Work Order ID 160172

DART SERVICE INSTRUCTION

TO AMEND INSTALLATION INSTRUCTIONS D350-607-3 Rev.D,
INSTALLATION INSTRUCTIONS D350-607-4 Rev. C AND
INSTRUCTIONS FOR CONTINUED AIRWORTHINESS ICA-D350-607 REV. 6

DRAWING NO. DSI 9699

FIGURE 1: INSTALLATION OF D4775-041 FWD STRUT

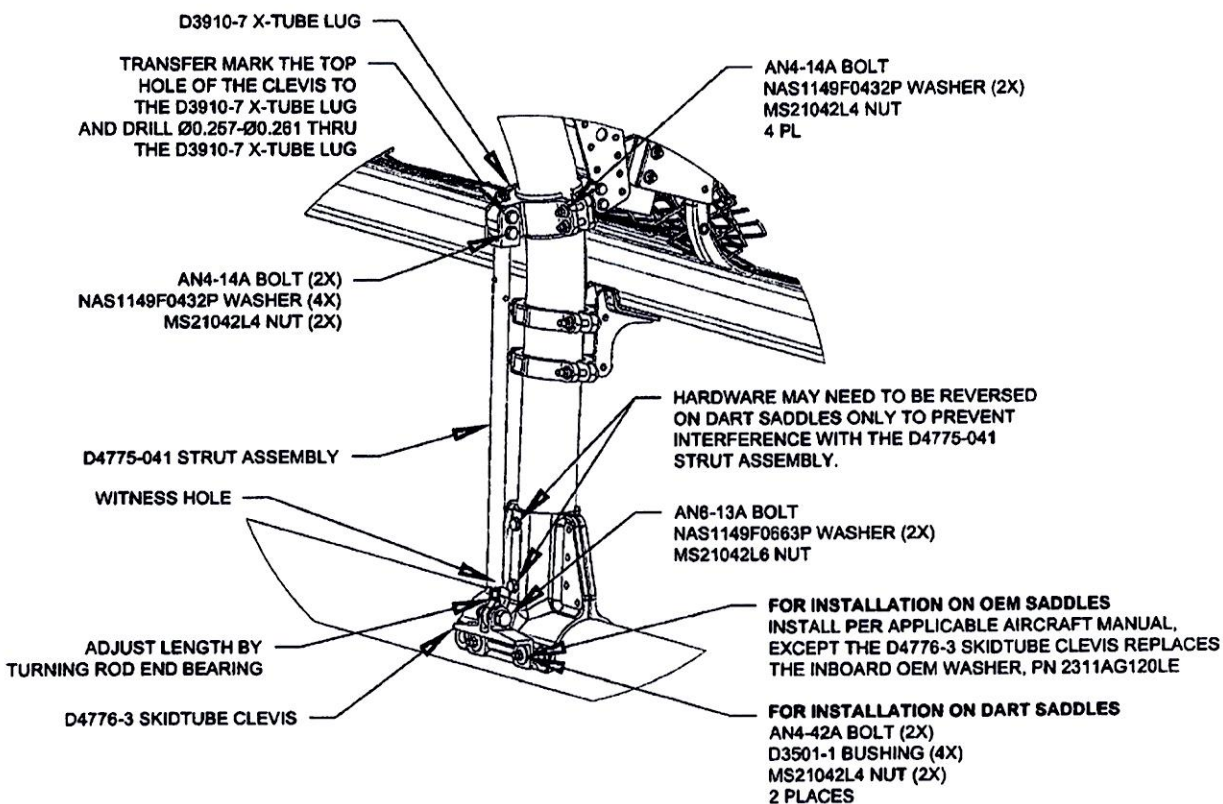
3.1 Substitute the Forward Lower D3910-5 X-Tube Lug with the D3910-7 X-Tube Lug as shown in Figure 1.

3.2 Install the forward D4775-041 Strut Assembly. Transfer mark from the upper hole on the clevis of the D4775-041 Strut Assembly to the D3910-7 X-tube Lug and drill thru the lug $\varnothing 0.257$ - $\varnothing 0.261$ as shown in Figure 1. Touch up chemical conversion coating per MIL-DTL-5541. Check the witness holes located at the bottom end of the D4775-041 Strut Assemblies to ensure that the thread from the rod end extends past the witness hole.
Torque MS21042L4/-4 nuts to 50-70 in-lbs (5.7-7.9 N-m). Torque MS21042L6/-6 nuts to 160-190 in-lbs (18.1-21.5 N-m).
